PROJECT REVIEW REPORT

Project ID	3430
Project Name	Juruá REDD+ Project
Review Type	Registration & Verification Approval
Program(s)	VCS Program
Verification Period	31 Jul 2020 – 30 Jul 2022
Project Proponent	Biofílica Ambipar Environmental Investments S/A e Ambiental Amazônia - Engenharia & Consultoria
Methodology	VM0015 AVOIDED UNPLANNED DEFORESTATION, v.1.1
VVB	Earthood Services Private Limited
Assessment Criteria	VCS Standard, v.4.4
Date of First Issue	11 September 2024
Date of Second Issue	9 May 2025
Review Conclusion	Approved
Date of Final Issue	4 August 2025

Figure 1. VVB cross-check of the project boundaries.

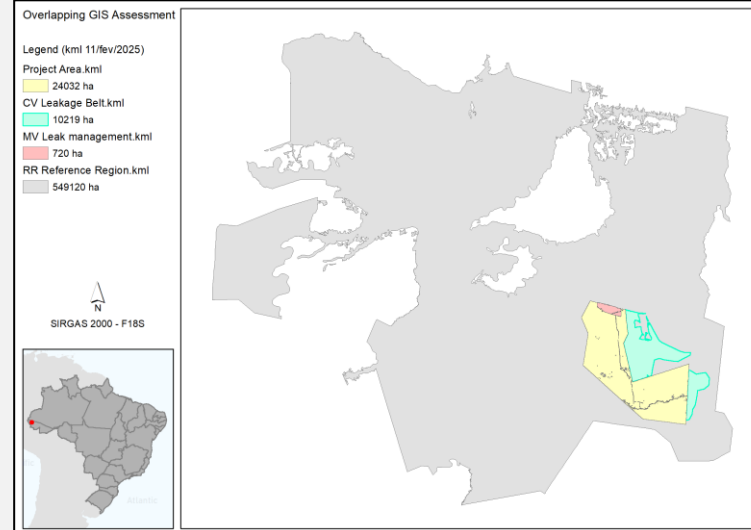
#	Finding Description	VVB Response	Status																									
2	Missing .kml files for project zones																											
	<p><u>Issue</u></p> <p>The KML file currently uploaded to the Verra Registry does not delineate the polygons of the following project zones:</p> <ul style="list-style-type: none"> • Reference Region, • Leakage Belt, and • Leakage Management Area, <p><u>Action Required</u></p> <ol style="list-style-type: none"> 1. The VVB must ensure that .kml files accurately delineates the polygons of all the applicable project zones. 2. The VVB must describe how they assessed all the applicable project zones in Section 3.1.8 of the joint V/VR. <p><u>Program Rule(s)</u></p>	<p>Round 1</p> <p><u>VVB Response</u></p> <p>The requested files have been uploaded to the F02 folder in response to the inquiry.</p> <p>The VVB reviewed the KML file titled “<i>Jurua_Project_limits_13-02-2025.kml</i>” and confirmed that it meets the requirements of Section 3.11.2 of the VCS Standard v4.5. The VVB also verified the project boundaries, which are consistent with those described in PD/MR v12:</p> <p><i>Table 1. VVB cross-check of the project boundaries.</i></p>

The minor differences (less than 0.2%) in values between the values can be attributed to two main factors:

- The process of converting rasters to shapefiles and then to KMLs can lead to changes in the areas, especially when undergoing reprojection between coordinate systems. The sequence of processing steps adopted can also contribute to discrepancies in the values.
- The method used to calculate the area in the GIS: Currently, the project proponent work with a standardized geographic database in the geodetic projection SIRGAS 2000, using the "reference ellipsoid EPSG:7030" parameterization. The software used for these calculations is QGIS.

<p>in the communication to the Verra Secretariat in the file “print Verra Registry.png”, dated February 13, 2025.</p> <p>The VVB concludes that the corrective action complies with the requirements of the VCS Standard, section 3.11.2 as the extent of the project is clearly specified and the following information is included: Name of the project area, maps of project zone, kml file with geodetic polygons precisely delimitating the project zone at the project start date, excluding the non-eligible parts, total size of the project zone , details of ownership, overlapping analysis and demonstration of control over the entire project area.</p> <p><u>Annexes:</u></p> <ul style="list-style-type: none"> - Jurua_Project_limits_13-02-2025.kml - VVB cross-check map.png - VVB cross-check.xlsx - print Verra Registry.png 	
		<p><u>Verra Response</u></p> <p>KML files of the reference region, leakage belt, and leakage management belt have been provided.</p> <p>The VVB has assessed the accuracy and appropriateness of the KML files.</p> <p><u>No further action is required</u></p>

Figura 54. Mapa das zonas de gestão territorial no âmbito do Zoneamento Ecológico-Econômico do estado do Acre - Fase III.

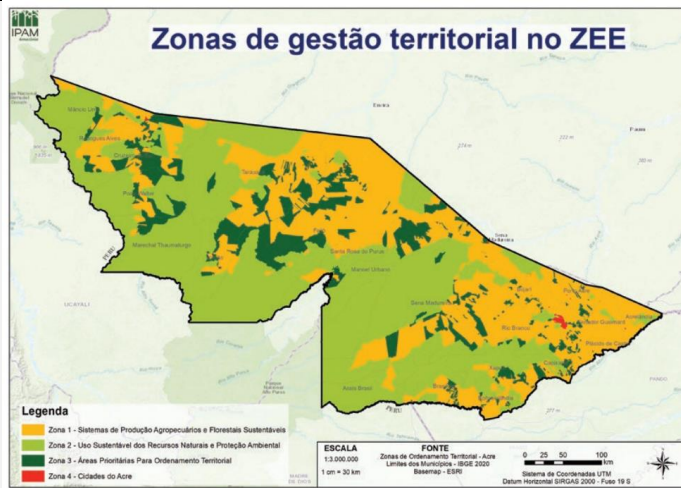
4	Missing justification for not stratifying the Reference Region (RR) and the Project Area (PA)		
	<p><u>Issue</u></p> <ol style="list-style-type: none"> 1. It is not clear if the RR and the PA are similar in terms of forest typology associations. 2. It is unclear if the Ecological-economical zoning of the State of Acre¹ was taken in account when defining the Reference Region (see background section). <p><u>Action Required</u></p> <ol style="list-style-type: none"> 1. The VVB must ensure that the joint PD/MR includes a clear justification for not stratifying the RR and the PA based on the different forest typology associations. 2. The VVB must ensure that the joint PD/MR includes a clear justification for not stratifying the 	<p>Round 1</p> <p><u>VVB Response</u></p> <ol style="list-style-type: none"> 1. The project proponent updated the Reference Region (RR) and demonstrated its similarity to the Project Area (PA) in terms of forest typology. Despite the presence of various forest typology subclasses, the PA is composed entirely (100%) of the "Open Ombrophilous Forest" typology. Similarly, all forested areas within the RR also consist entirely (100%) of "Open Ombrophilous Forest". <p>Regarding the lack of stratification of the RR into forest sub-typologies, the project proponent provided a clear justification in Section 5.1 of PD v12 ("<i>Estimation of the average carbon stocks of each LU/LC class (Step 6.1.1 VM0015)</i>", "<i>a) Existing forest classes within the Project Area</i></p>	Closed

<p>RR and the PA based on the different Enforced policies and regulations (envisaged in the Ecological-economical zoning of the State of Acre).</p> <p>3. The VVB must update the joint V/VR to provide its assessment accordingly.</p> <p><u>Program Rule(s)</u> VM0015, v.1.1</p> <p><u>Background</u> Forest typology The project area encompasses 4 clearly distinct forest typology associations as described in Section 1.13 of the joint PD/MR, which are used for ex-ante estimations. Section 3.3 of the joint PD/MR reports that 100% of PA is open Ombrophilous forest, while only 67.1% of the RR is constituted by this typology.</p> <p>Ecological-Economic zoning The joint PD/MR identifies territorial planning issues among the main problems facilitating the occurrence of deforestation, mentioning the “Ecological-economical zoning of the State of Acre”. This document presents relevant differences in terms of spatial planning (i.e. land management zones) that seem correlated with deforestation dynamics.</p>	<p><i>and Leakage Belt”</i> – page 138 of PD). The justification states that, statistically, there is no significant difference in biomass stock across these sub-typologies.</p> <p>The VVB reviewed and assessed the project proponent’s justification and concluded that it clearly demonstrates no statistical differences in biomass and carbon stocks among the forest sub-typologies. Therefore, classifying the forest typology of both RR and PA as "Open Ombrophilous Forest" is justified.</p> <p>This justification aligns with the criteria for defining LU/LC classes ("Forest-land"), as specified in requirement 2.2 of VM0015 v1.1 (page 31).</p> <p>The VVB also verified the RR update to ensure compliance with the similarity criteria in relation to the PA. Both the PA and RR are composed entirely (100%) of "Open Ombrophilous Forest", meeting the requirements of section 1.1.1 of VM0015 v1.1 (page 19).</p> <p>2. The project proponent updated Section 3.3 of PD and demonstrated that the Ecological-Economic Zoning (ZEE) was the source of all data used in the spatial analysis, including the variables applied in the deforestation risk and allocation model. The deforestation risk model incorporates a variable for land tenure status, identifying areas located on private properties, glebes, settlements, and other public lands (Table 11 of PD v12).</p> <p>Although the overall deforestation quantity was defined globally, the model provides a mechanism to allocate projected deforestation based on the relative importance of each tenure class (along with other factors) in shaping</p>

The VVB verified that the project incorporated the ZEE of Acre State to define the Reference Region, as detailed in Section 3.3 of PD v12. Table 11 of PD v12 illustrates how each land tenure class contributes to deforestation within the RR, based on ZEE data. This table helps substantiate the identification of deforestation agents within the project.

3. The VVB updated Sections 3.4.3 and 3.4.6 of V/VR accordingly. The validation team concludes that the explanation provided in the PD/MR and the evidences provided (shapefiles) are reliable, based on public available data and sufficient to conclude that there is no need to stratify the RR and PA.

1. Section 3.3 of the PD/MR has been updated to provide description clarity that 100% of the forest typology in RR and PA is the Open Ombrophilous Forest. Clarification has also been provided that the variation is from the forest subclass. Furthermore, the VVB has assessed the updated information regarding the RR and PA forest typology in Section 3.4.6 of the V/VR.
2. Section 3.3 of the PD has provided clarification that the ZEE was considered in the spatial analysis and the deforestation risk assessment.
